PHOTOGRAPHS

PHOTOGRAPH #6

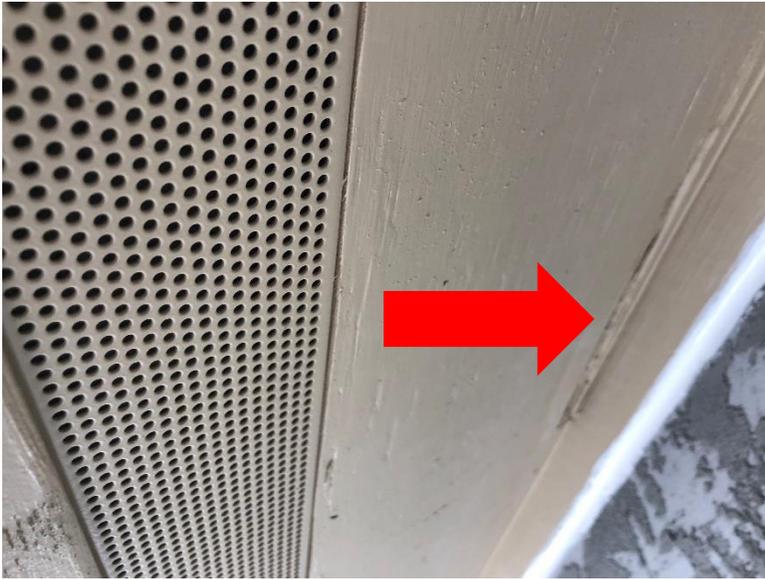
Kick out roof flashing is lacking kick out angle, full bed of mastic and trimming away of eave closure metal at kick out.

PHOTOGRAPH #9

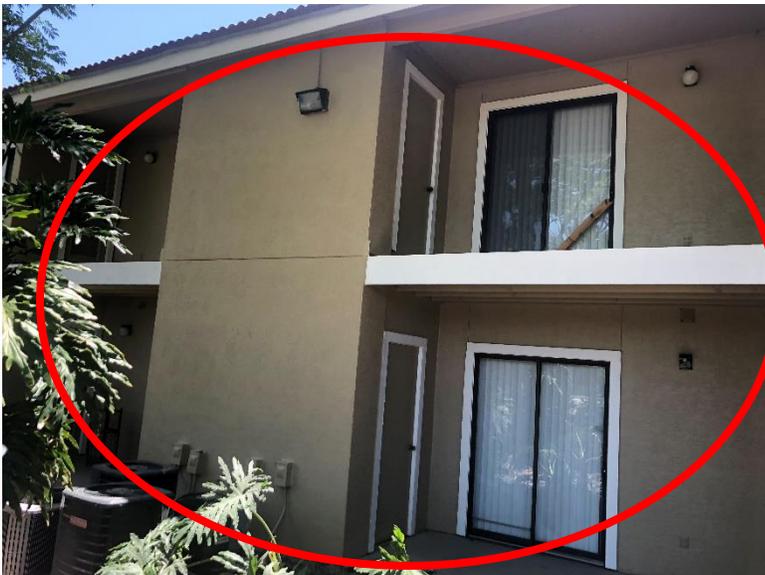
Kick out roof flashing is lacking kick out angle and separation from edge of barrel tile.
